From: Barna, Roberta (EXT) <[REDACTED]>
Sent: 14 September 2026 16:50
To: Jane Curley
Cc: Planning (SMDC)
Subject: DOC/2025/0040 - Fole Dairy (LLFA Response)

Staffordshire County Council Flood Risk Management Position

We require additional information to discharge the drainage conditions. We would therefore recommend that Conditions 13,15 and 16 are not discharged until this has been resolved. Outstanding issues are listed below (for previous discussions see the email chain):

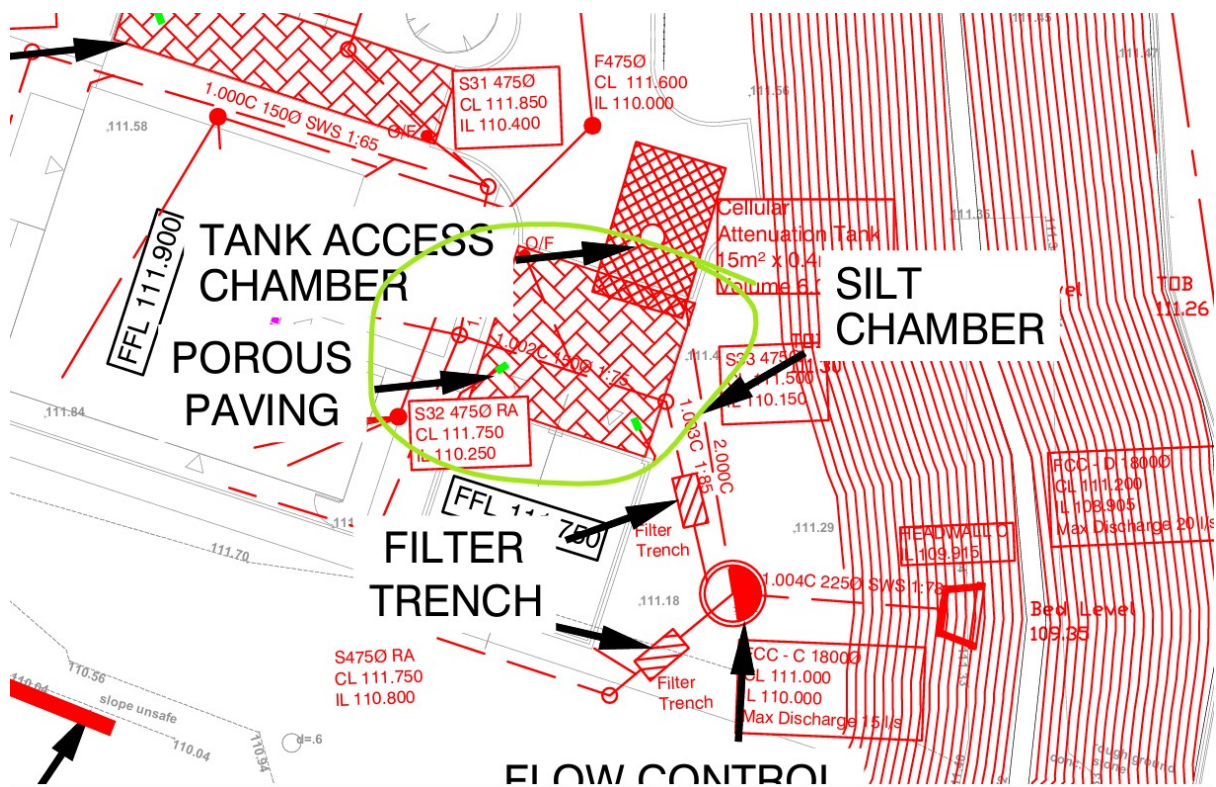
- The latest drawing shows the watercourse very close to Plots 37 and 48. We need to see that there is adequate protection against scour and adequate bank protection (there's 2cumecs of water going down this ditch in the modelling). We will provide protection to the bank with a membrane layer, see attached drawing 21047-302. The drawings now include an erosion control blanket for slope stabilisation, however no hydraulic assessment has been provided demonstrating that the proposed erosion protection is suitable for the modelled flows within the swale.

- Structural assessment to be provided for structural integrity of buildings to protect against erosion. See attached drawing numbered 21047-SK100. Whilst sections showing the swale in relation to the adjacent plots have been submitted, no geotechnical or structural assessment has been provided to demonstrate that erosion, scour or long-term bank instability will not affect the structural integrity of Plots 37 and 48.

At the northern end of the site an interceptor ditch and bund are proposed to capture any overland flow passing towards the site from overtopping of Uttoxeter Road".

I refer you to the approved flood risk assessment, Figure 3-2 shows that in the post-development scenario, water is not predicted to fully overtop the road and enter the interceptor ditch during the 100-year plus 31% climate change event. Figure 3-7 shows that in the same flood event if there was a blockage at the structure along Uttoxeter Road water would cross the road and enter the interceptor ditch. Figure 3-8 shows that in the modelled 1,000-year scenario

water is predicted to overtop Uttoxeter Road and enter the ditch. Therefore, the model results indicate that only in extreme flood events or in the event of a blockage during an extreme event the ditch would be active. I therefore do not see the need to have any additional bank protection other than what is being currently proposed, because the ditch is only going to be used in an extreme event has noted above, I see no further reason to demonstrate that erosion scouring or the long term bank stability will affect the structural integrity of plots 37 and 48.

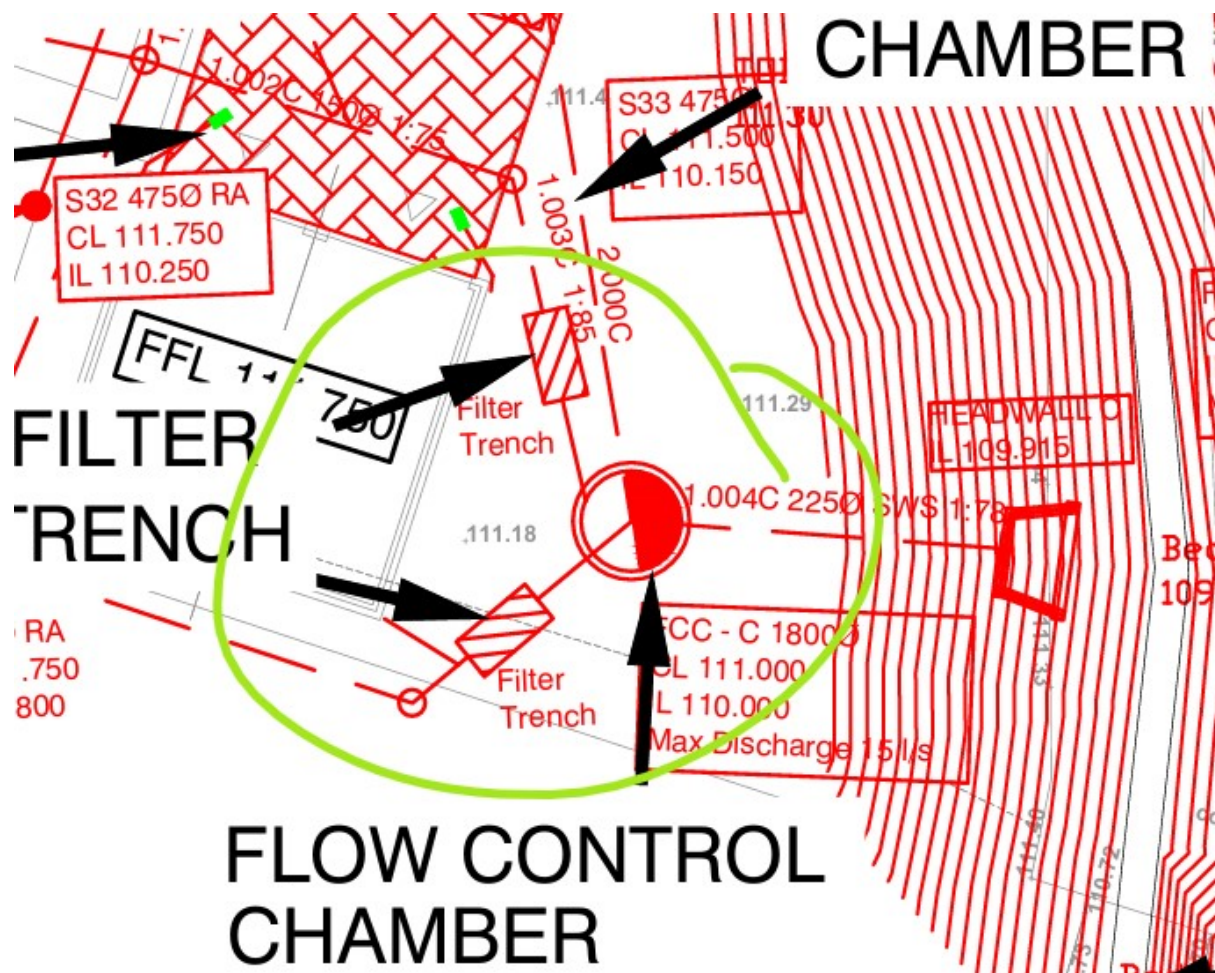
- Will the digger need to cross Tank C? And does this have similar compressive strength as outlined for Tank A? (if so, that's fine because of the cover level being higher than Tank A). **Note added on drawing, I confirm this is the case.**
- For the Permeable paving: Please confirm that you'll have the Load Category 6 PP along the whole road/parking area needed for the digger to access the positions in the digger reach diagram (where you've got PP shown in the plan on the western bank of the watercourse and the area of parking that it may need to cross circled in the screenshot below: **Note added on drawing, I confirm this is the case.**

- Please also confirm provide information for the pipes, filter trench and HB in this area for suitability for digger loading. **Note added on drawing, I confirm this is the case.**

- Filter trenches – confirm if the digger would need to track directly over the filter trench or stand with one track over the trench. If so, we need to see a structural assessment because no loading classification detail is provided for the filter drains. **I have moved the filter trench.**
- Same for the pipework and flow control chamber in this area, will the digger need to cross these to access the watercourse / stand in this area, and if so, provide structural assessment to confirm it can withstand the loading. **I have added a note on the drawing with the appropriate specification.**

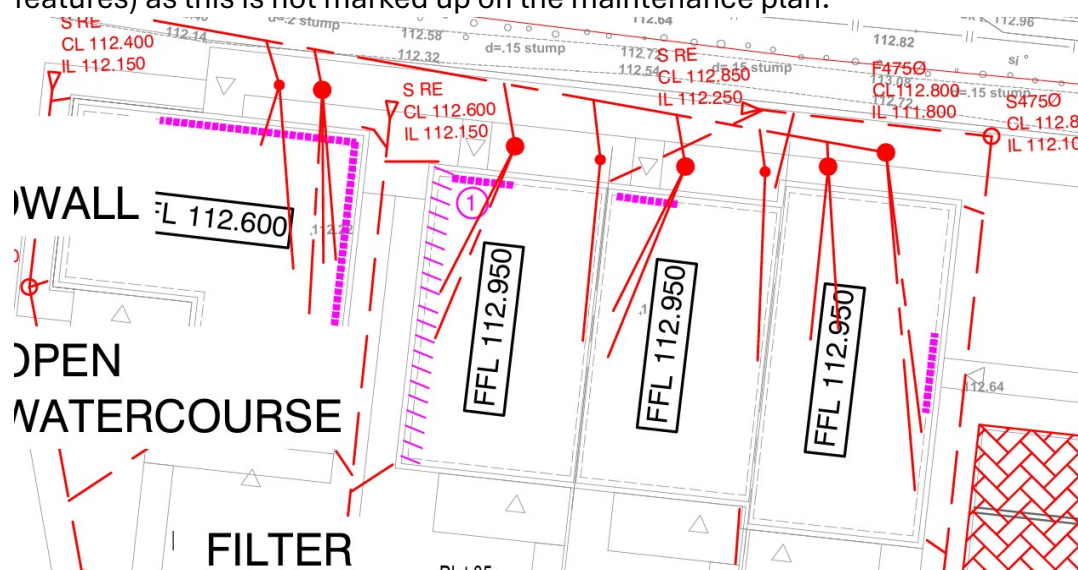
- Can you supply an updated drainage plan with the updated highway drainage proposals (as per the maintenance plan) so this can be listed as an approved document.
- On the overall maintenance plan can you confirm what the pink features denote (see examples in screenshot below) and who will these be maintained by (if they are drainage features) as this is not marked up on the maintenance plan.

Drainage has been updated; pink features have been removed.
